DESIGN REVIEW BOARD MAY 20, 2016

ALPHARETTA CITY HALL
COUNCIL CHAMBERS
2 PARK PLAZA
8:30 AM

RE: Design Review Board – Landscape Review Response to Comments
HGOR #14095

1 RENDERING
1" = 1'-0"

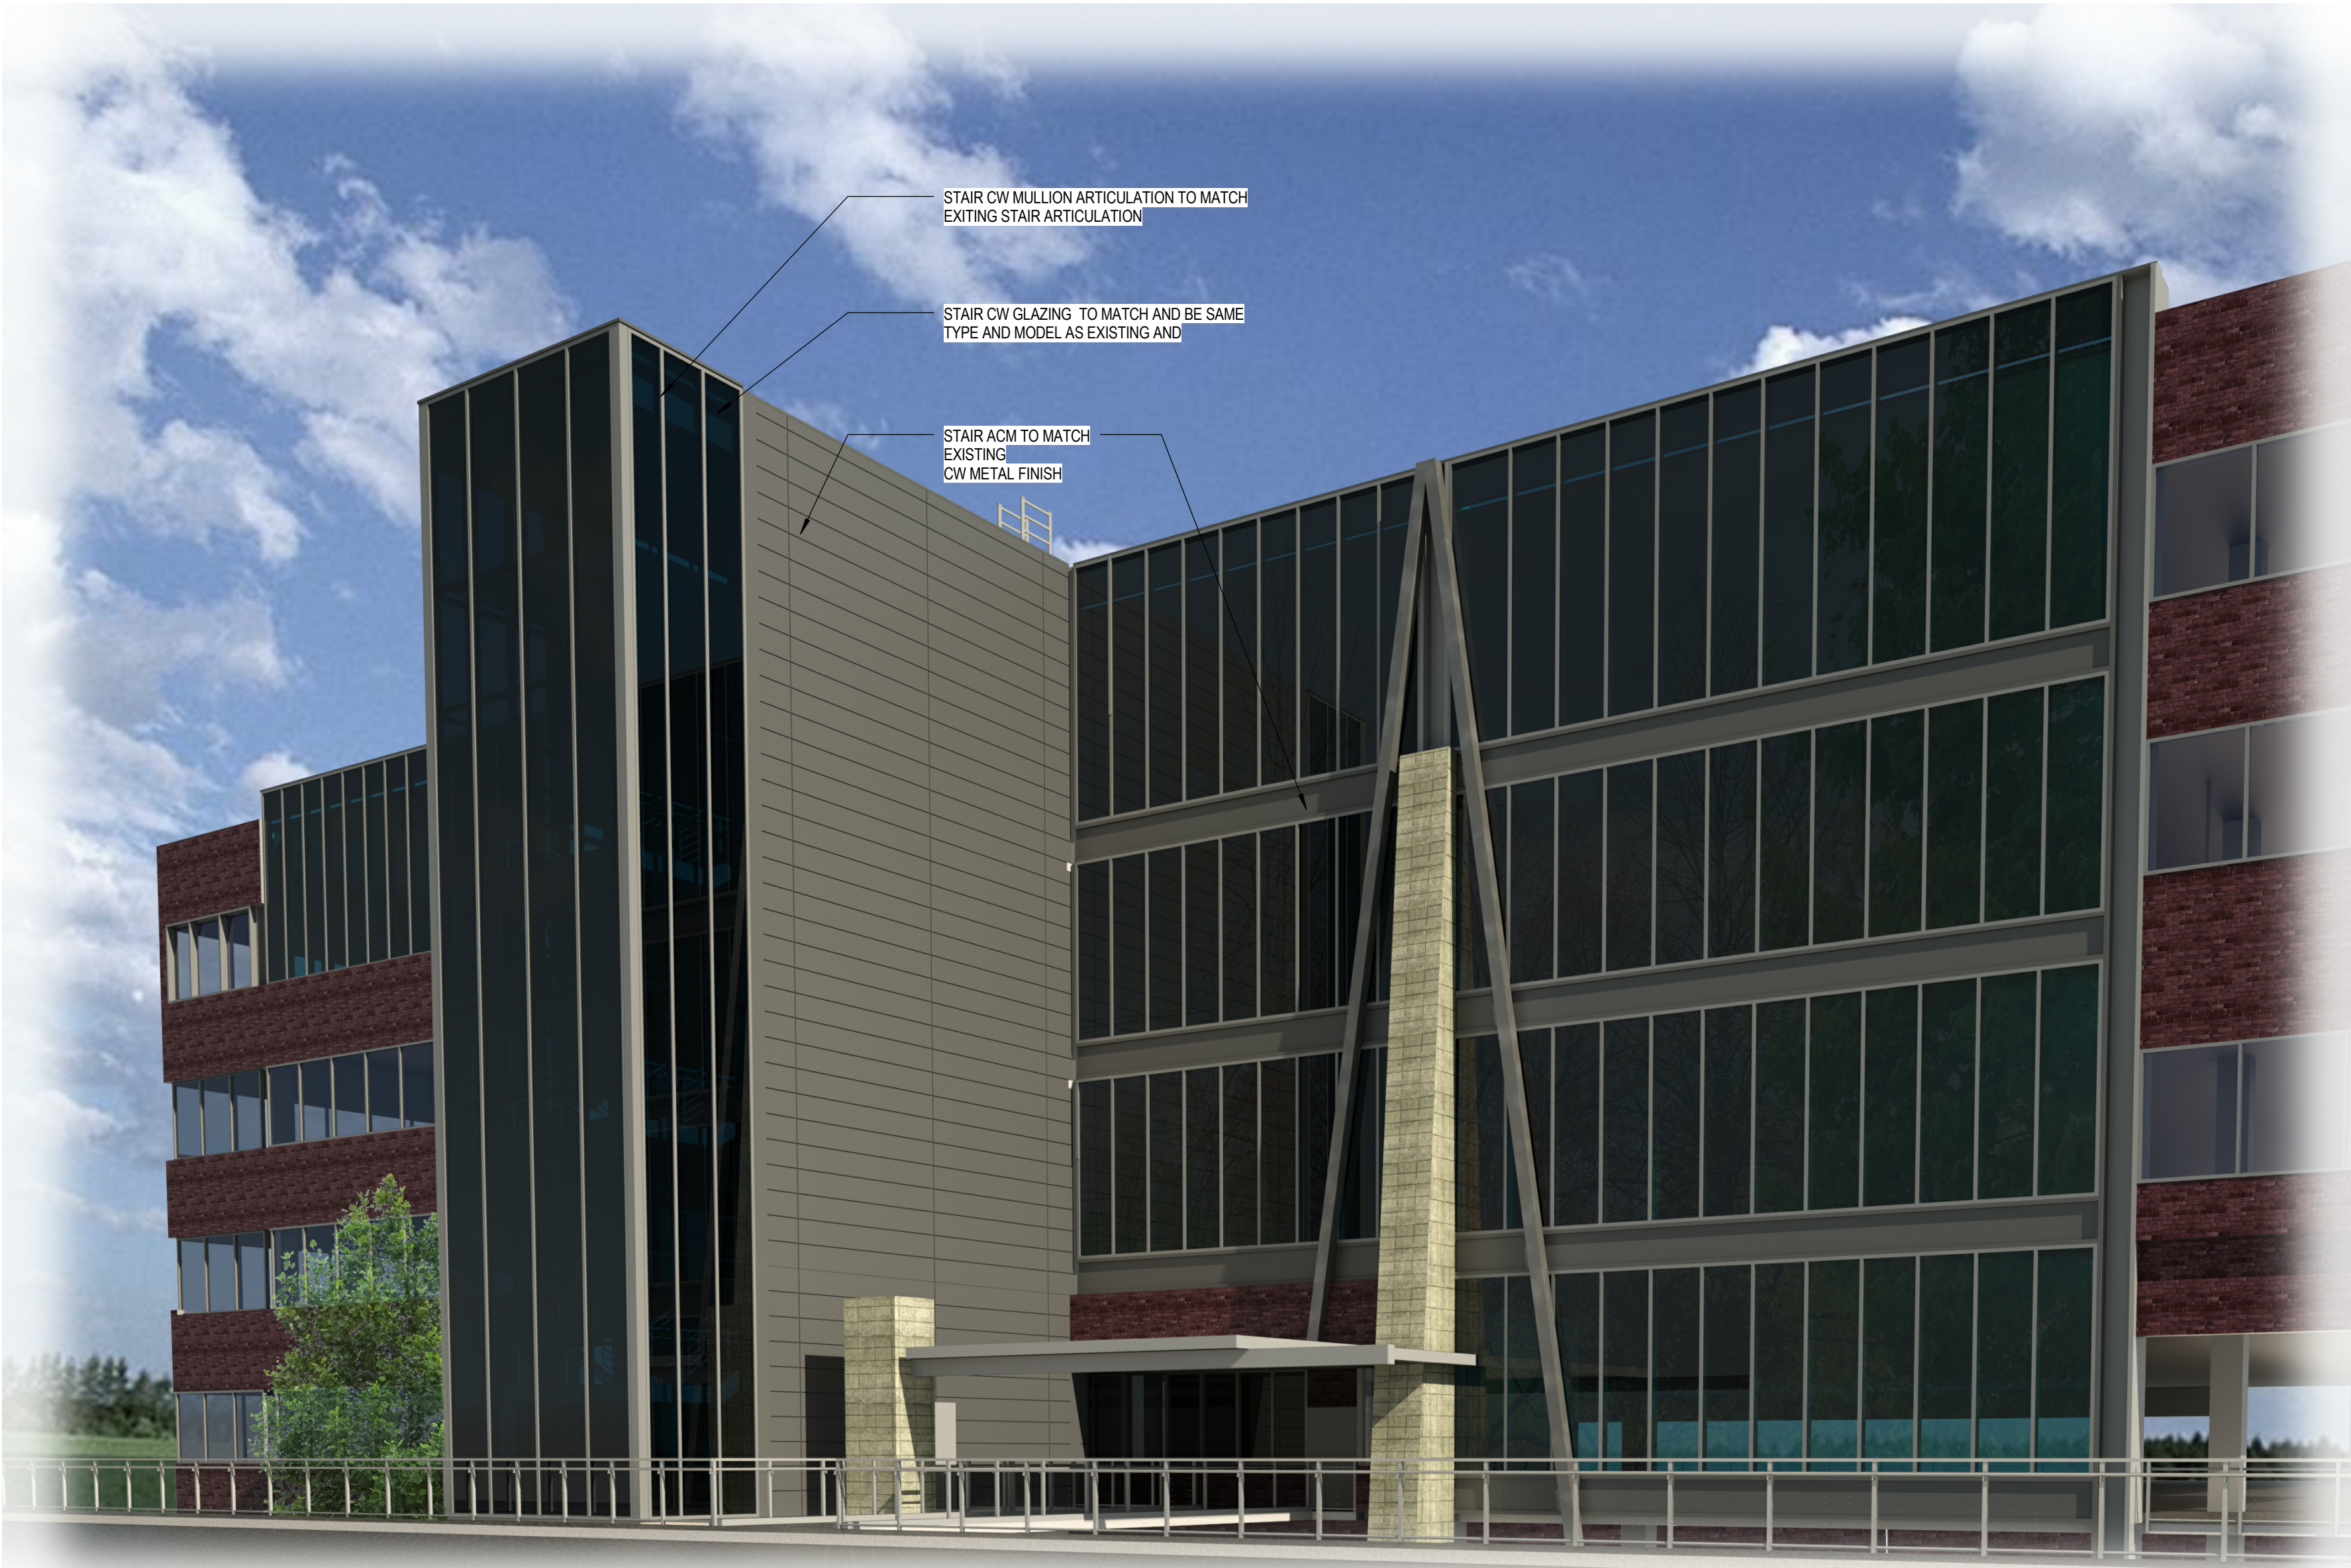
G000.1 Addition of sheet A752 "Exterior Rendering" onto the drawing index;
A752 Addition of exterior rendering to clarify Design intent of providing for all stair finishes to match existing building systems per city request
